ACCESSIBLE BARRIER REPORT

2010 American's with Disabilities Act
and
2015 IBC with ICC A117.1-2009

WESTERN
NEW MEXICO UNIVERSITY

Western New Mexico University Campus – Accessibility Overview

(1)

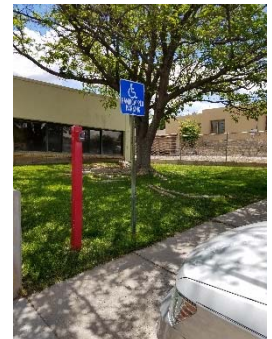
Parking (1) – The designated accessible parking is close to the apparent entrance; however, a sign directs the person down the hill to the Sechler Rhoades Hall for entry. This is confusing to a person with a disabled placard trying to park and enter the building under the designated conditions. We suggest eliminating the identified accessible space and creating an additional accessible parking space closer to the designated public entrance. The existing slopes are greater than 2.08% (varies from 4 to 7% as measured), **(2)** incorrect signage is provided (See Figure 2 signage requirements attached) one accessible parking space should be designated as Van accessible, **(3)** striping and International Symbol of Accessibility (ISA) need to be provided/repainted.

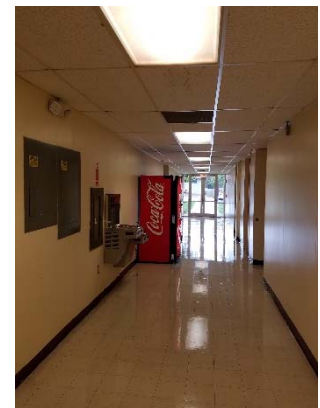
Exterior Accessible Route - The path of travel to the entry doors is compliant, except one or more sections have raised more than 1/4" max vertical at control joints and would require grinding to meet the requirements of Figure 303.3.

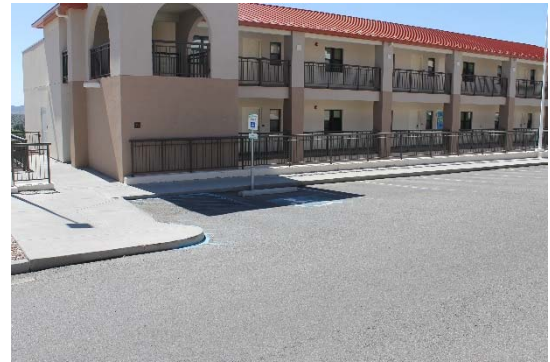
Interior Barriers – The interior of the accessible rooms appear to be compliant as measured, except at the closets which had the clothes hanging rods located above the 48” maximum height and the bottom of the closet should provide a shelf at 15” minimum to achieve the reach range of a person in a wheelchair per Section 308 of the ICC A117.1-2009 (as applicable with situation provided per Figures 308.2.1 to 308.3.2 attached).

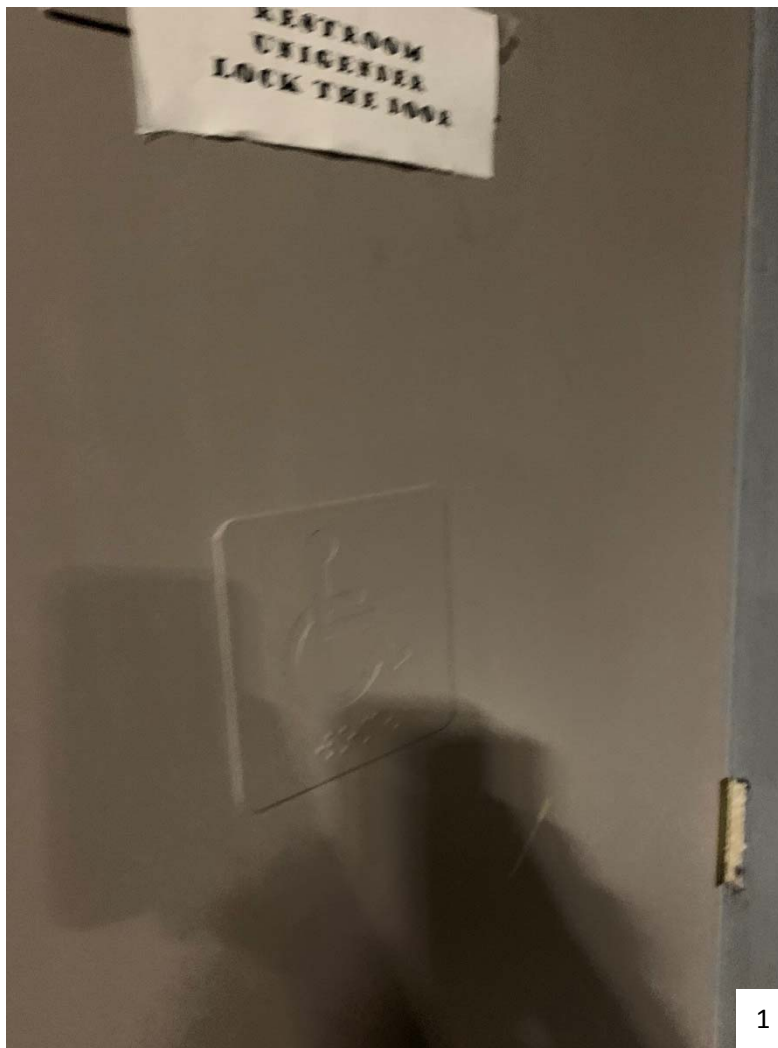
Interior Barriers – Carpet in recital room not fastened to floor surface (Photo 5). It is a tripping hazard.

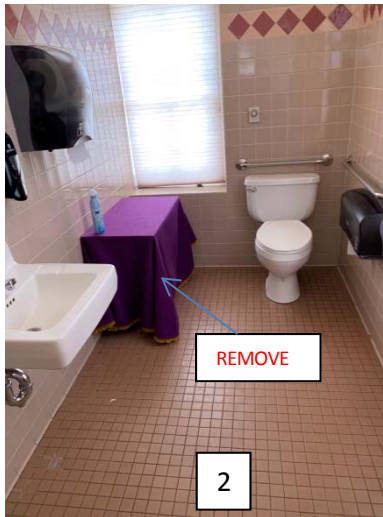
Building Entrance - Entry door on the 1st floor is equipped with round door knobs (Photo 1). These need to be replaced with door handles having parts that are operable with one hand and do not require tight grasping, pinching, or twisting of the wrist to operate.

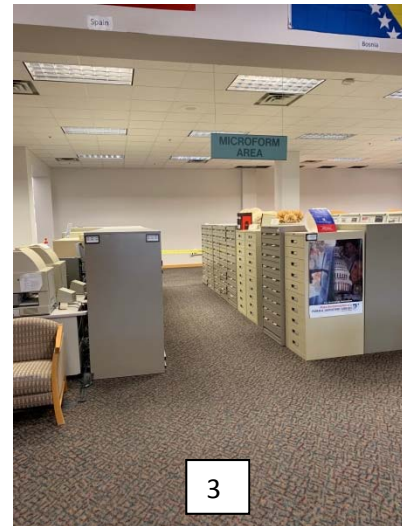
Interior: Carpet in foyer is blistering and will be a trip hazard until replaced (Photo1). The top row of the periodicals section shouldn't be higher than 48 inches and if it is, there should be a sign indicating that you can ask for assistance to reach higher placed materials (Photo 2). The checkout counters, at the microfilm areas, reference and help desks are higher than the 36” requirement (Photo 3).
